# Memo

**From:** Sarah Hanson, Natural Environment Officer, Planning

**Date:** 25 January 2022

**Re:** Consultation on an Application

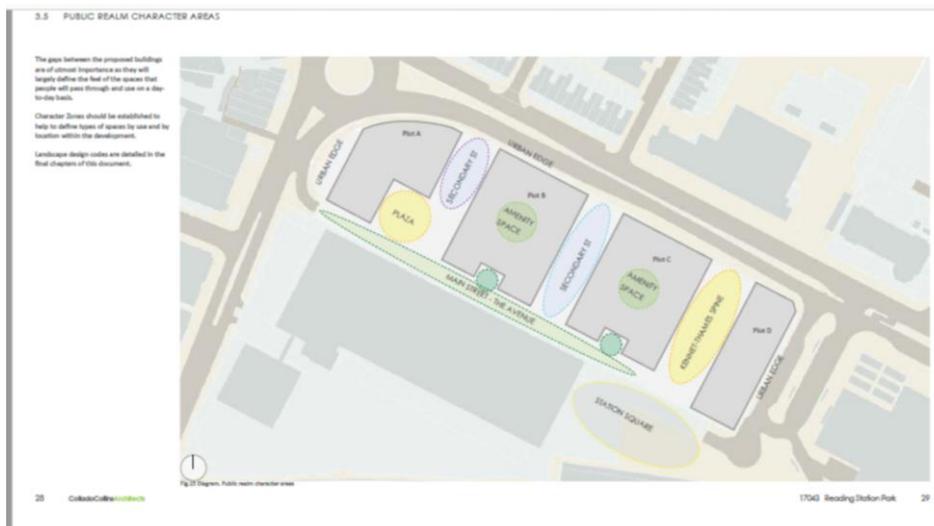
Given the above, landscaping will be an integral part of this site to provide the 'in principle' features indicated in the RSAF and to meet local plan policies and the aims of our Tree Strategy (along with the BAP, Reading Climate Change Action Plan, to respond to Reading climate emergency and aim for a carbon zero Reading by 2030). In addition, there should be a landscaping link with adjacent sites through use of species. Whilst a complete repeat of species from one site to the next should be avoided in order to improve species diversity, a selection of a few common species between sites is desirable to provide a link.

Principles (as advised at an early stage) should include:

- Retention of good quality established trees where feasible
- A net gain in tree number across the sites – preferably 3 for 1
- Species link through the sites (each applicant will have to be aware what the other is proposing – given the advance stage of the Royal Mail site, SSE have used those species proposed to guide their own planting palette)
- Species selection to respond to the microclimate, e.g. shady areas, windy locations, polluted frontages
- Species selection as way-finding
- Species selective to provide diversity (including avoiding over-represented species in the Borough, e.g. Prunus and Tilia)
- Species selection to provide wildlife value
- Creation of 'avenue' planting, particularly along the north-south route which should aim for a double row (potentially staggered).
- Use of large canopy species

- Perimeter planting along the Vastern Road and Caversham Road frontages
- Defensive planting to respond to secure design concerns
- High quality tree pits, including use of root cells to provide sufficient rooting volumes within hard landscape areas
- Use of green walls and roofs
